POINT BEACH NUCLEAR PLANT INDIVIDUAL PLANT EXAMINATION
TECHNICAL EVALUATION REPORT
(FRONT-END)

**Point Beach 1 and 2 Technical Evaluation Report
on the Front End IPE Submittal**

Technical Evaluation Report
NRC-04-91-066, Task 22

Science and Engineering Associates, Inc.

Figure A-3. Mass Flow Rates for Feed and Bleed

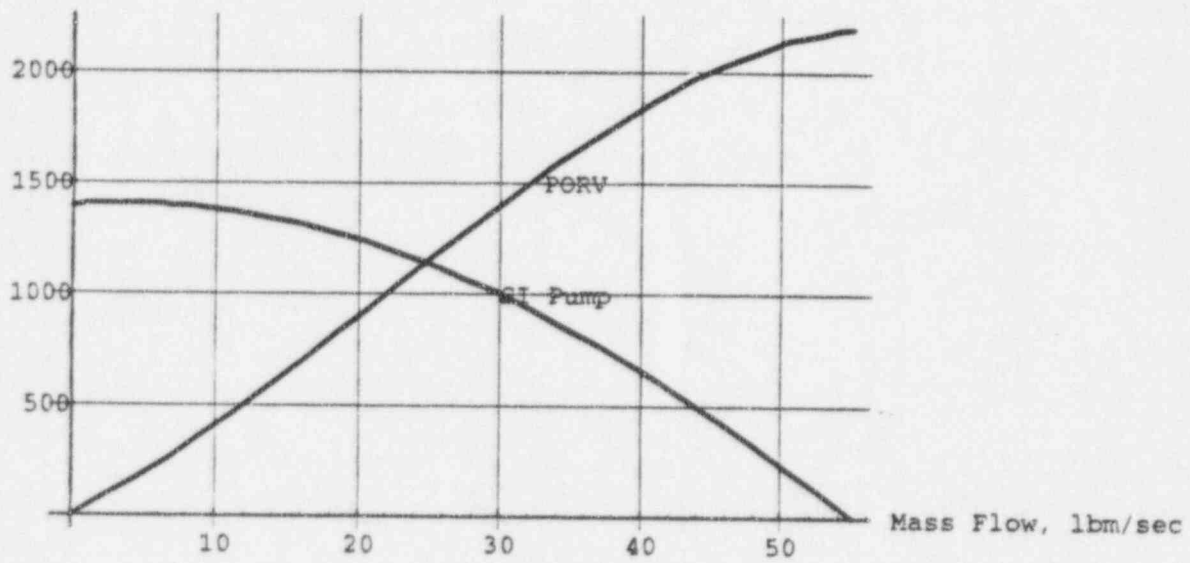
We evaluated the ability to feed and bleed. Based on Figure 14.3.1-1 of the UFSAR and information on PORV relief capability from the Submittal in Section 3.1.4.1, we generated Figure A-3 using the interpolating polynomial curve fitting capabilities of Mathematica. We assumed that the pressurizer will be steaming when the vessel level drops sufficiently to uncover the pressurizer surge line in the hot leg.

The curve for PORV relief as a function of pressure is based on a Moody model with an effective PORV area calculated from the data in the Submittal for relief capability at a given pressure. Figure A-3 indicates that the 'match' point for makeup and loss is 25 lbm/sec at 1150 psia. Assuming feed with 100 F water and steaming out the PORV at 1150 psia, the heat that can be removed is

Figure A-4. Probability of Non-Recovery of Offsite Power

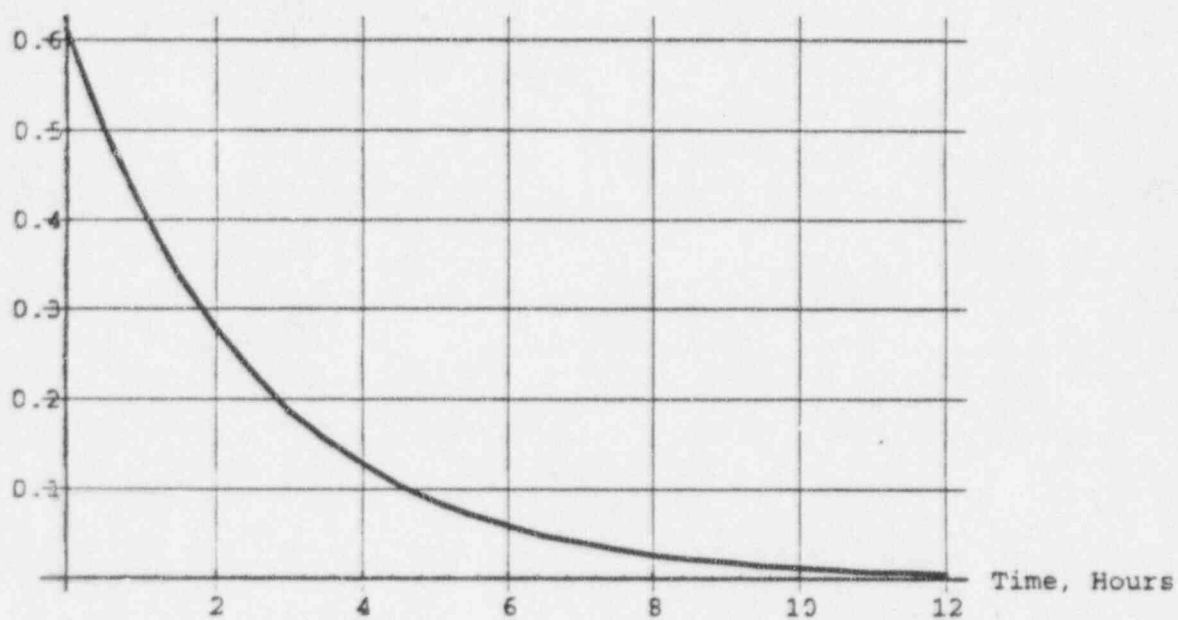
This curve cannot be correct at short times. For example, the curve indicates a probability of non-recovery of 0.61 at time 0 which cannot be right; at time 0 the probability must be 1.0. For times of about an hour or later the data from the curve agrees with typical non-recovery data. We conclude that the curve fit used did not fit the data for early times. The licensee responded that the curve for non-recovery of offsite power does not apply for early times; the likelihood of core uncover prior to 30 minutes was taken as 0.0 based on the seal LOCA model. [IPE Responses]

Figure A-5. Probability of RCP Seal LOCA

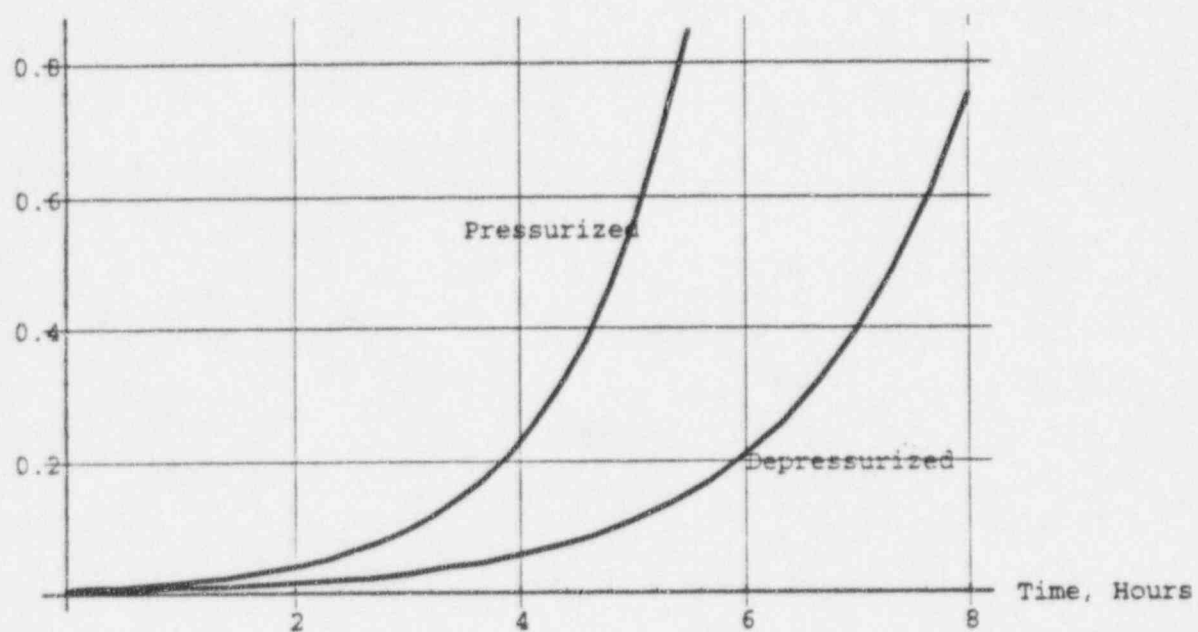
Evidently the upper limit in equation (X) is intended to be $t_i - 3$ where t_i is the sequence-specific time for core uncover without off-site power if no RCP seal LOCA occurs. PROB-SL is based on the assumption that core uncover from a seal LOCA occurs 3 hours after the RCP seal LOCA; thus, RCP seal LOCAs within the time interval $(t_i - 3, t_i)$ do not contribute to core uncover within time t_i . However, an RCP seal LOCA within the time interval $(t_i - 3, t_i)$ does affect the time to core uncover by increasing the mass loss from the primary system; in effect, the RCP seal LOCA reduces the time T . The model does not address this effect since it excludes consideration of a seal LOCA within time $(t_i - 3, t_i)$. One conservative way to address this issue is to use T instead of $t_i - 3$ as the upper limit of integration.

- (1) the integrand contains the error of equation (V)
- (2) the upper limit $t_i - 3$ is not correct.

The licensee responded to both these issues. [IPE Response] Calculations were redone with the error in equation (V) corrected and with the upper limit specified as T . The overall impact on the change in CDF was very small.
